**SEMINOLE COUNTY GOVERNMENT**  
 1101 EAST FIRST STREET, 2ND FLOOR, WEST WING  
 SANFORD, FLORIDA 32771

<b>PROJECT NAME:</b>	<b>TALLY-HO ESTATES - PRE-APPLICATION</b>	<b>PROJ #: 23-8000027</b>
APPLICATION FOR:	DR - PRE-APPLICATION DRC	
APPLICATION DATE:	2/17/23	
RELATED NAMES:	EP EDWIN WHITE	
PROJECT MANAGER:	JOY GILES (407) 665-7399	
PARCEL ID NO.:	22-21-31-517-0000-0030	
PROJECT DESCRIPTION	PROPOSED SUBDIVISION FOR FOUR SINGLE FAMILY LOTS ON 5.89 ACRES IN THE A-1 ZONING DISTRICT LOCATED NORTHEAST OF EAST CHAPMAN ROAD AND HAPPY HORSE POINT	
NO OF ACRES	5.89	
BCC DISTRICT	1-BOB DALLARI	
CURRENT ZONING	A-1	
LOCATION	NORTHEAST OF EAST CHAPMAN ROAD AND HAPPY HORSE POINT	
FUTURE LAND USE-	LDR	
SEWER UTILITY	SEMINOLE COUNTY UTILITIES	
WATER UTILITY	SEMINOLE COUNTY UTILITIES	
<b>APPLICANT:</b>	<b>CONSULTANT:</b>	
EDWIN D. WHITE 2140 HAPPY HORSE POINT OVIEDO FL 32765 (407) 664-6870 LARSDWHITE2019@GMAIL.COM	LARS WHITE 2160 HAPPY HORSE POINT OVIEDO FL 32765 (407) 664-6870 LARSDWHITE2019@GMAIL.COM

## FLOODPLAIN

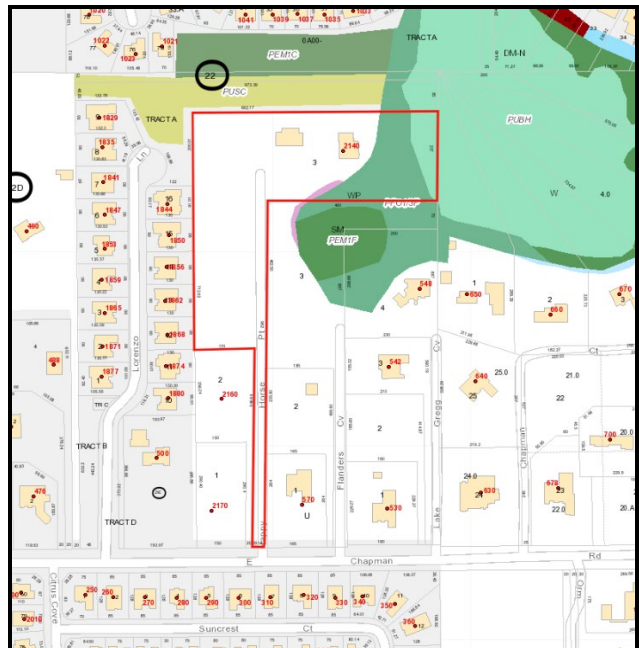
36.	Public Works - Engineering	Based on FEMA FIRM Map the site or portions of the site appear to lie in the floodplain. Seminole County does not allow fill in the floodplain without equal volumetric compensation.	Informational
